DEPARTMENT OF PARKS AND COMMUNITY SERVICES

Subject: 4-Way Ranch Commercial Metropolitan District Review (ID-23-002)

**4-Way Ranch
Commercial
Metro District**

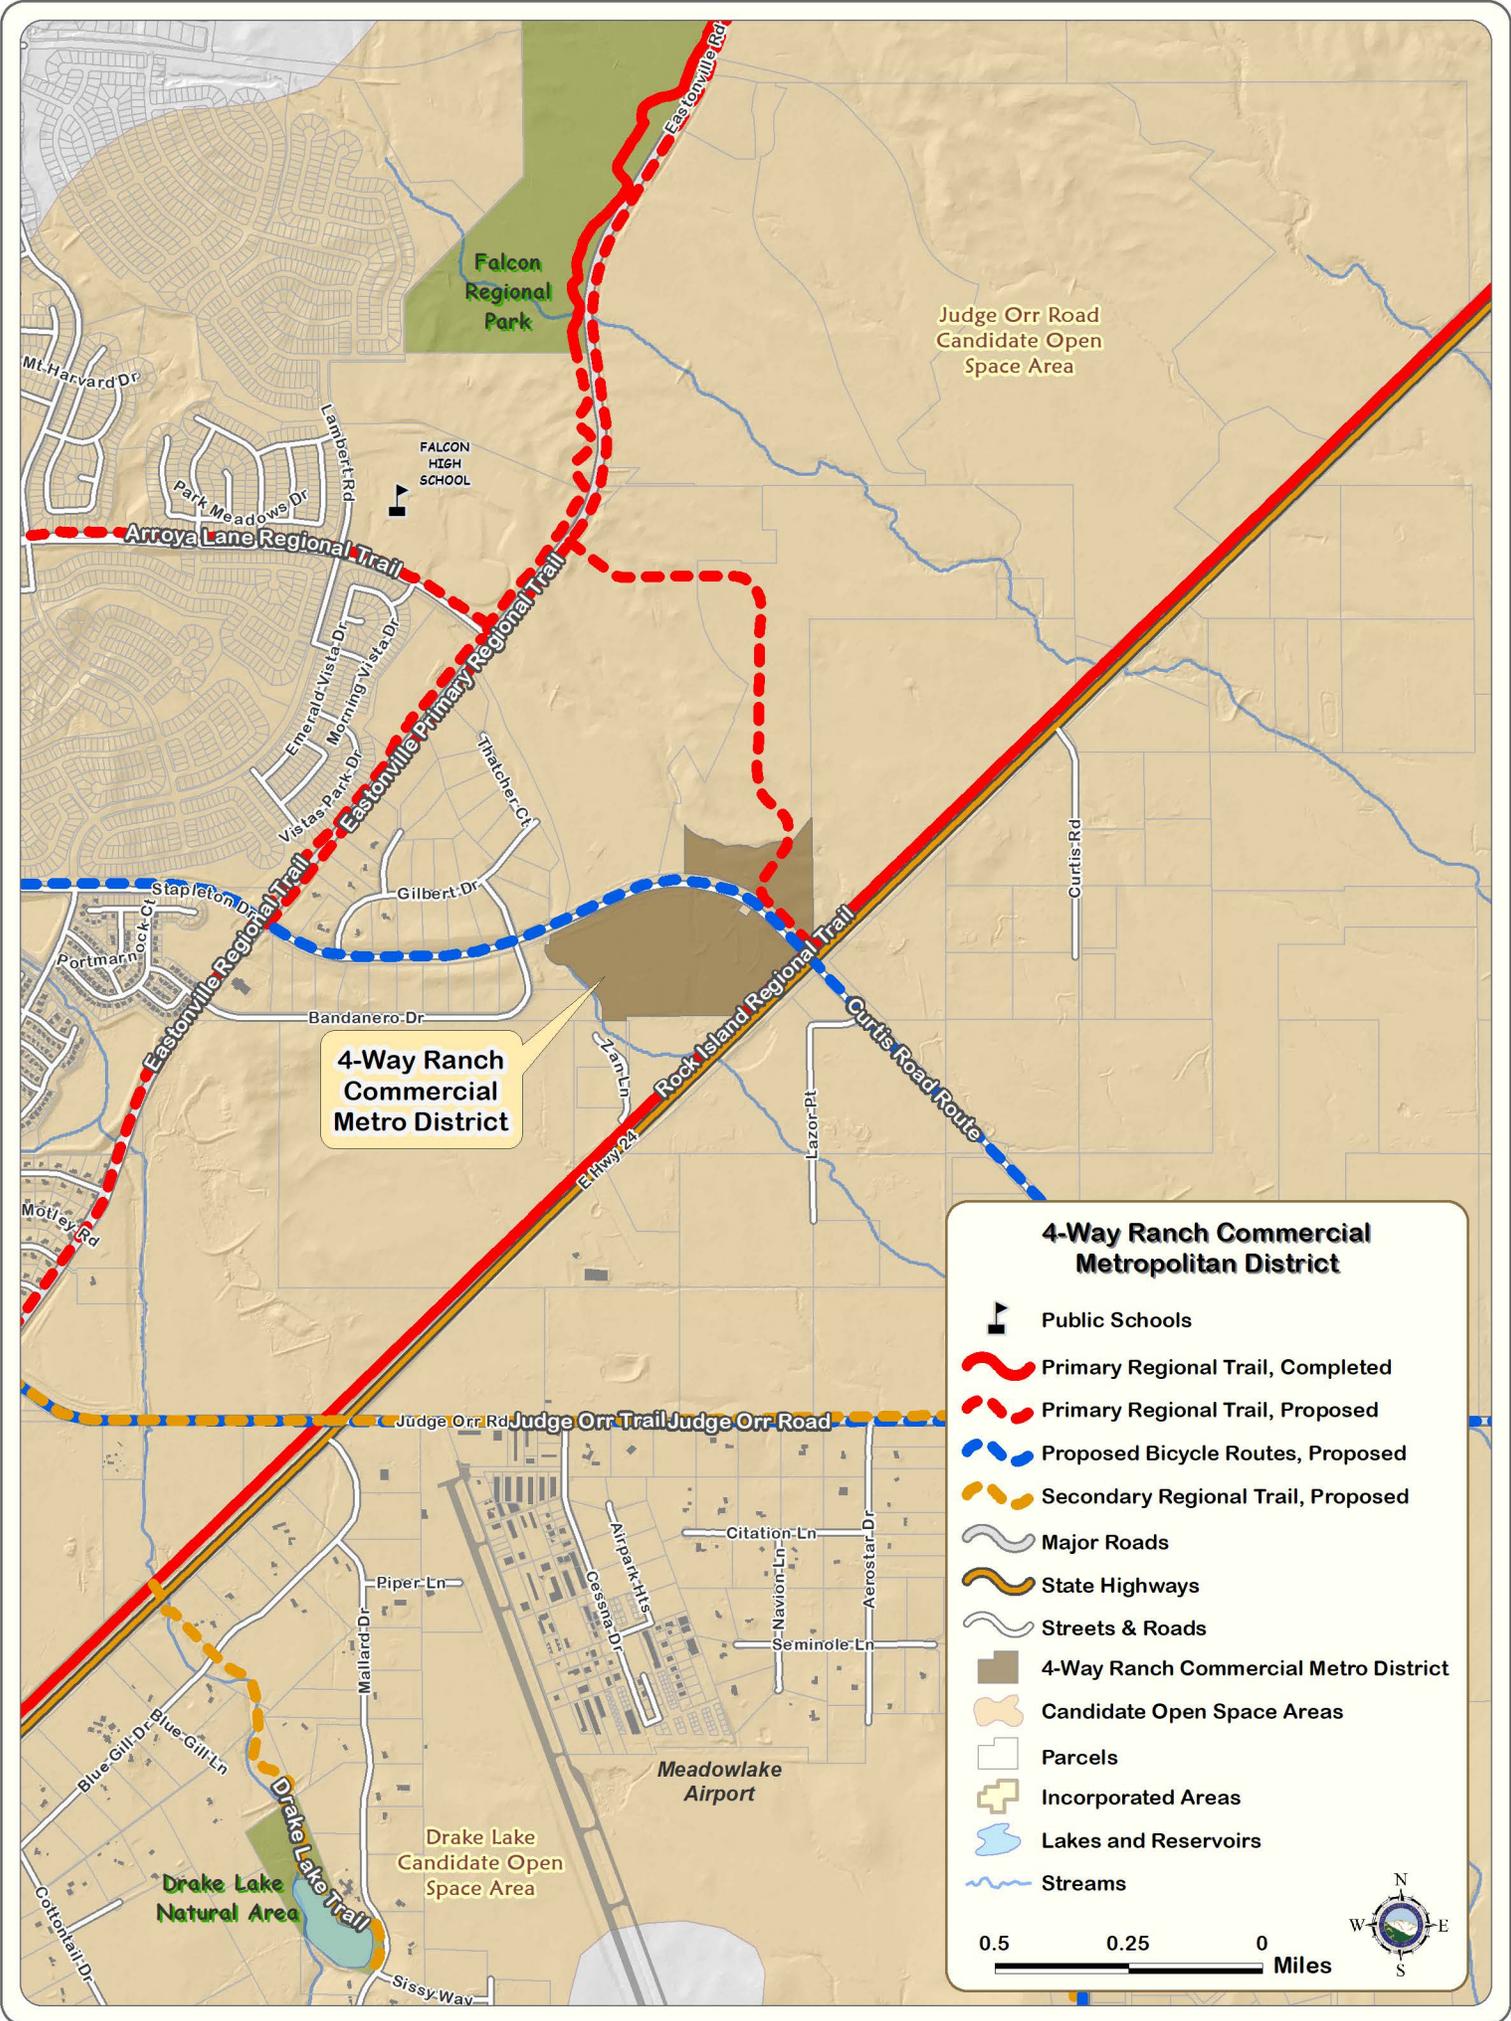
The 2022 El Paso County Parks Master Plan shows a proposed regional trail impacted by the project. The proposed Arroya Lane Primary Regional Trail runs north-south through the northern portion of the metropolitan district. This trail provides a critical east-west connection from the proposed Sand Creek Primary Regional Trail in the west to the existing Rock Island Primary Regional Trail, near the project's eastern boundary at East Highway 24. The master planned alignment is based upon the original Waterbury preliminary plan and generally follows a major internal street corridor, and as such, the trail would utilize the street's sidewalk system, albeit enlarged to 8-feet in width to follow EPC Parks primary regional trail standards.

Furthermore, the proposed Curtis Road Bicycle Route runs east-west through the project site, utilizing Stapleton Road along this particular section. Dedicated public right-of-way already exists along the aforementioned bicycle route, so no easement request is necessary at that location; however, the applicant is advised that multi-modal transportation options will be developed within the right-of-way in the future.

Due to the commercial nature of the metropolitan district, the development of recreational facilities is not anticipated. However, the applicant should be aware of the impact to the proposed Arroya Lane Primary Regional Trail corridor. The applicant is encouraged to not only work closely with El Paso County Parks staff when designing transportation infrastructure, but also with the developers of Waterbury to determine the most efficient alignment for the aforementioned regional trail. When a final trail alignment is settled upon, El Paso County Parks may or may not require a trail easement for the Arroya Lane Regional Trail, depending on whether the trail is standalone in nature - such as being located in a drainage corridor - or a widened sidewalk as part of the local transportation network.
